Report for An Bord Pleanala

**Appeal against Refusal to Issue Regularisation Certificate
(FA/18/1644/REG)**

4 Upper Gardiner Street, Dublin 1

Client: An Bord Pleanala
An Bord Pleanala Ref: ABP-304090-19
Our Ref: ABP_R002_Issue 1
Date: 15th July 2019

- Diagram 8 of TGD-B 2006 recommends a 1.8m distance from unprotected windows /elevation to an external escape stair. It also looks for a 3.0m distance at the foot of the stair.

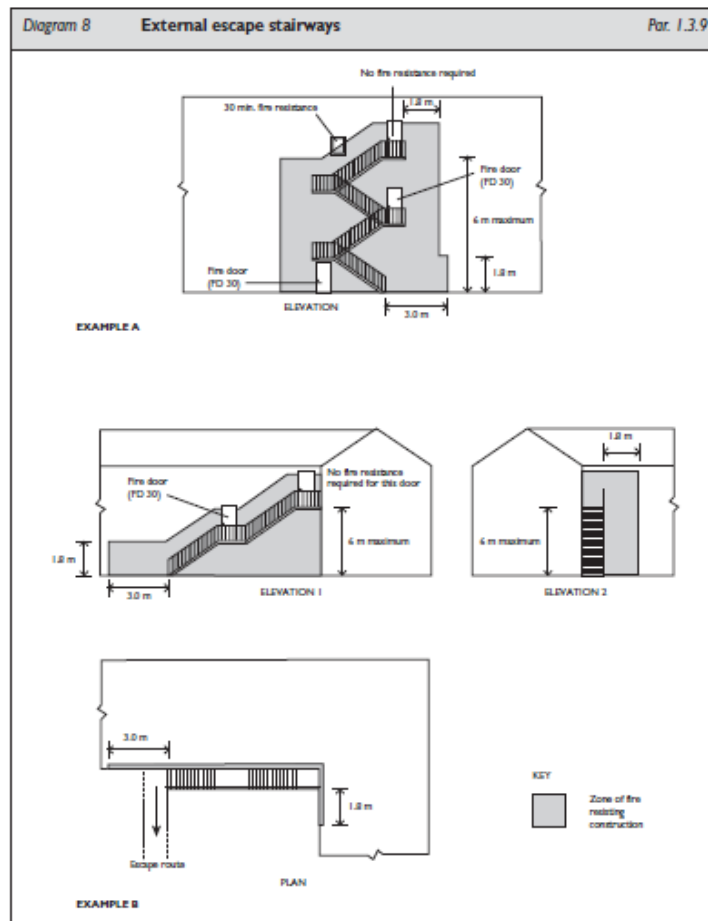
In all the above a 3m distance is a common dimension and would seem to give a reasonable distance that can be considered remote.

With a 3m distance from the foot of the stair to the cooking facilities, the Appellant's alternative layout for Flat 4 and 5 would now comply and in Flat 3 the distance would only have to be increased 400mm.

In all flats with galleries the main kitchen cooking appliances should be located at least 3m away from the escape route from the gallery level. A main kitchen cooking appliance is a cooking appliance with a fixed connection to the flat's gas or electric energy infrastructure (e.g. an oven and / or hob).

- Clause 1.5.2 (iv) of TGD-B 2006 recommends that in an open-plan arrangement in a house the stairway can be open if it is 3m or more from the kitchen: -

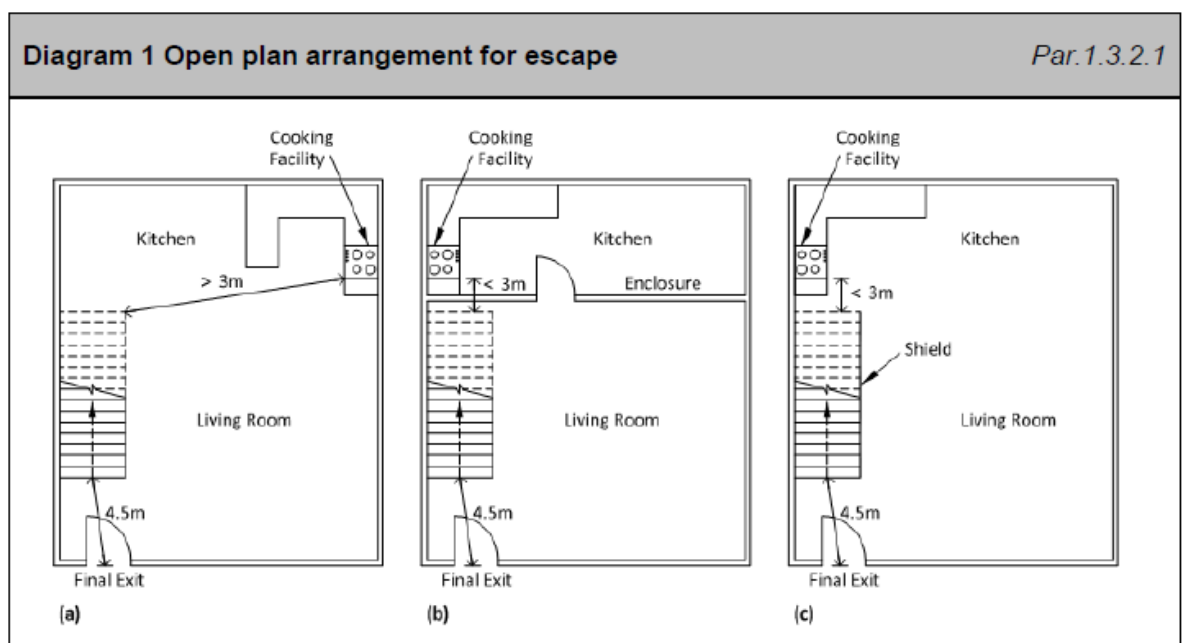
An open-plan arrangement, where the stairway rises directly from the ground storey accommodation is less preferable than the arrangement at (ii) above and is only acceptable where:

- the stairway discharges to within 4.5 m of a door at the ground storey leading directly to the open air;
 - the stairway does not discharge into a kitchen and either:
 - any ground storey kitchen is enclosed in storey height construction which need not be fire resisting or;
 - where the stairway passes within 3 m of the kitchen, the stairway should be enclosed in storey-height construction which need not be fire-resisting;
 - a fire detection and alarm system is provided, in accordance with 1.5.5;
 - all habitable rooms at the upper storey are provided with windows for escape or rescue in accordance with 1.5.6; and
 - the design meets the general provisions for dwelling houses, outlined in 1.5.8.
- Diagram 1 of TGD-B 2017 Volume 2 recommends a 3m distance from the cooking facility and the open stair in an open plan arrangement: -
